CONTRACT CHANGE ORDER NO. 216
SHEET 34 OF 55

SAN FRANCISCO OAKLAND BAY BRIDGE
EAST SPAN SEISMIC SAFETY PROJECT

YBI TRANSITION STRUCTURES - HINGE K

HINGE KE & KW EXPANSION JOINT DETAILS NO.1

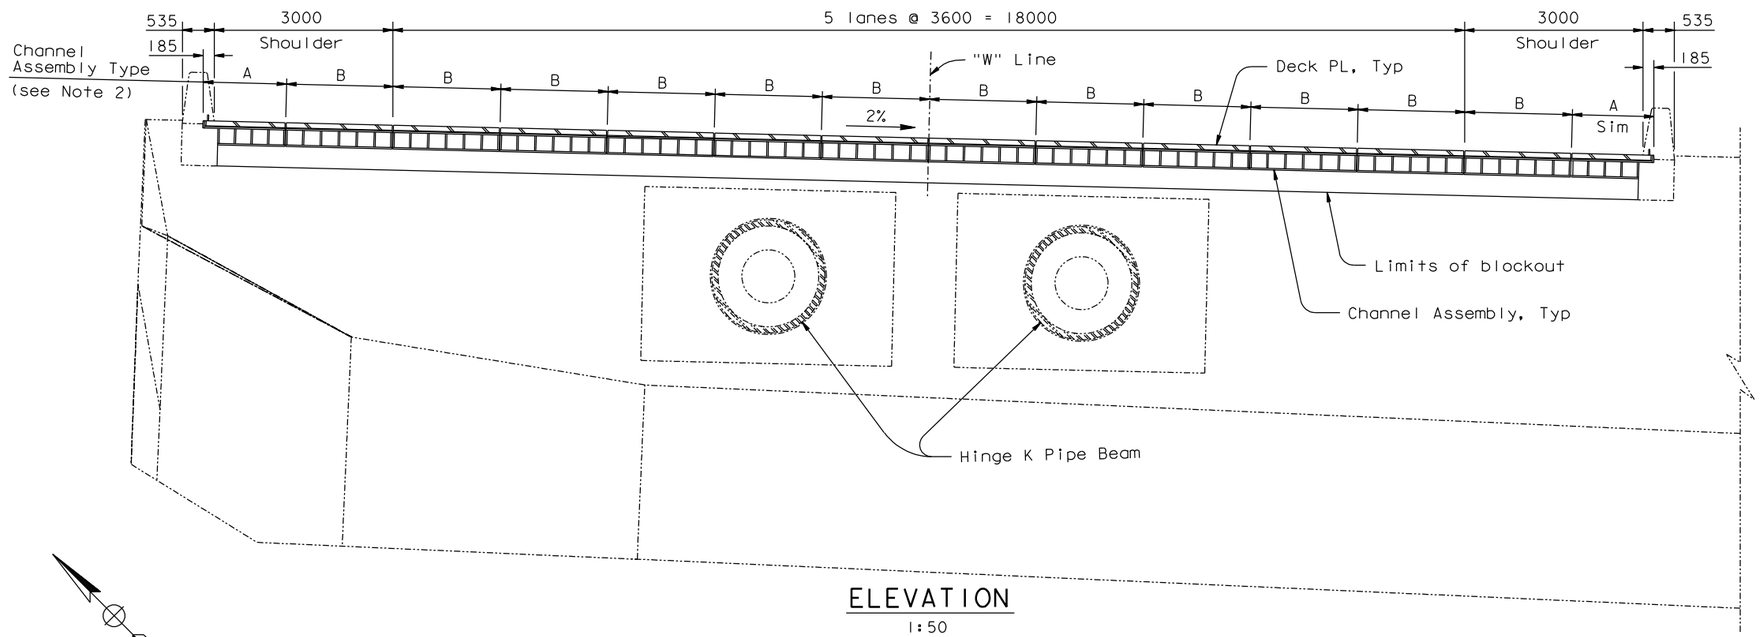
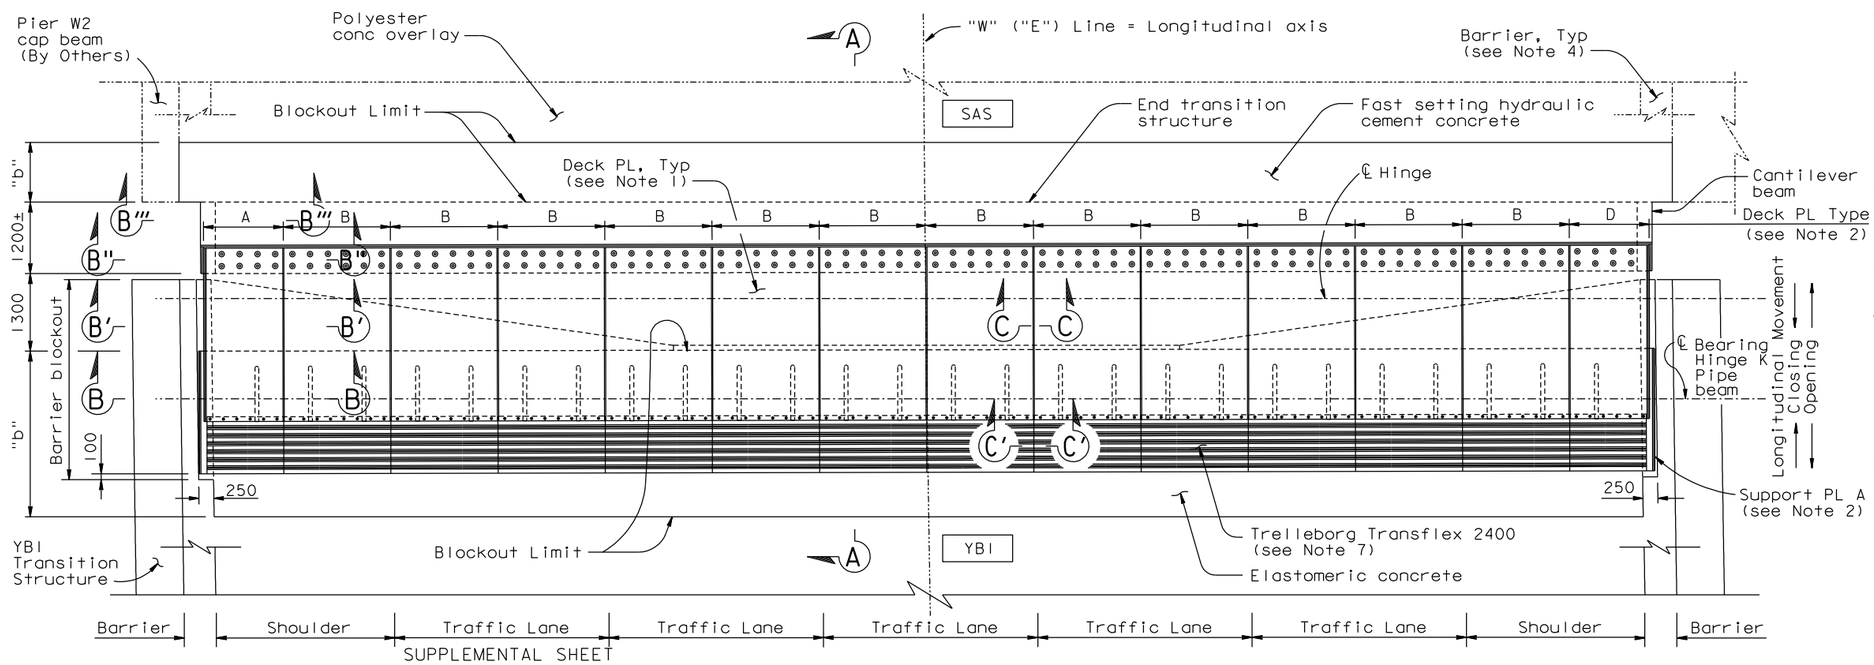
MARK	DATE	DESCRIPTIONS	BY	CH'D	CCO#
0	01/20/12	YBI CLOSURE POUR	RM	MW	216
